Section 78 Appeal @ Land south of The Paddock, Old Wrexham Road, Gresford, Wrexham.

MEMORANDUM

Development: Outline application for proposed residential development to form 8 no. mews style properties in two blocks of 4 no. units with central access point and associated parking to rear.

- 7.5t Panel Van
- Overall Length 7.210m
- Overall Width 2.192m
- Min Body Ground Height 0.544m
- Track Width 1.316m
- Lock to Lock Time 1.865m
- Kerb to Kerb Turning Radius 4.00s
- 7.400m

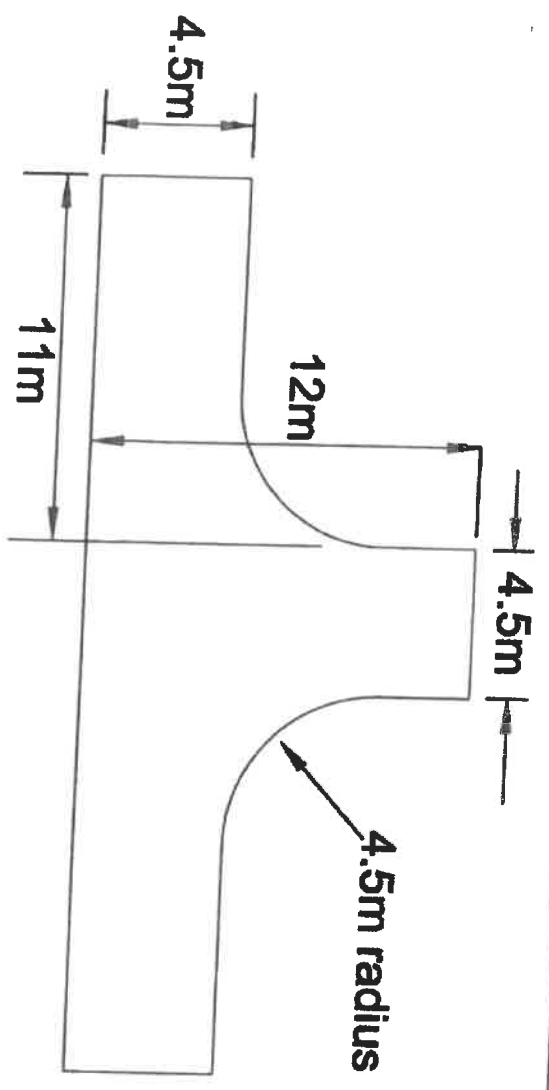
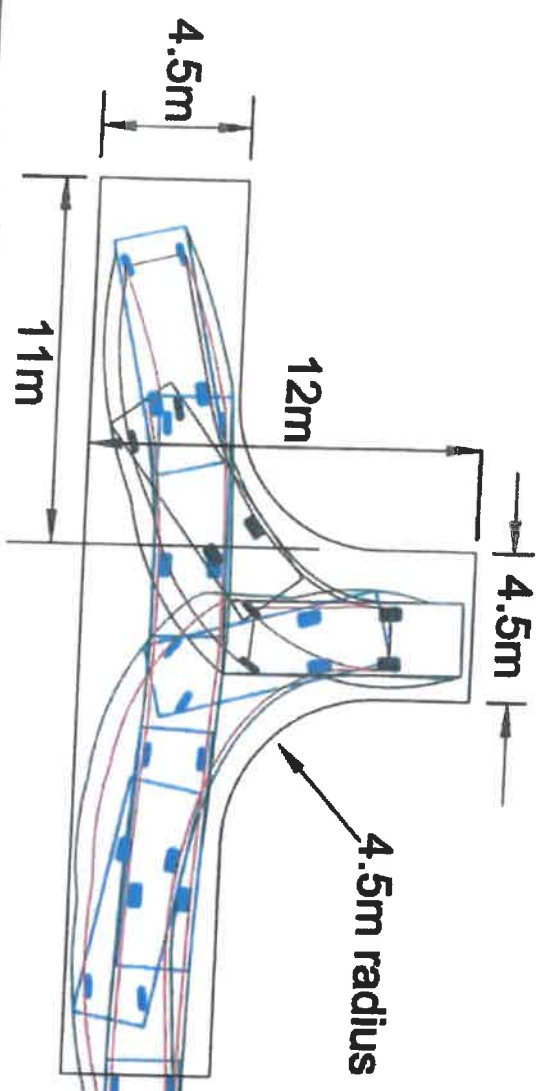
The submitted layout plan does not detail a suitable turning head to WCBC adoptable standards which is unacceptable (see attached detail). However, it may be possible to provide sufficient space for such a facility at the end of the estate road / parking area. **Could you please ask the applicant to provide a revised layout plan indicating / annotating the required turning head dimensions.**
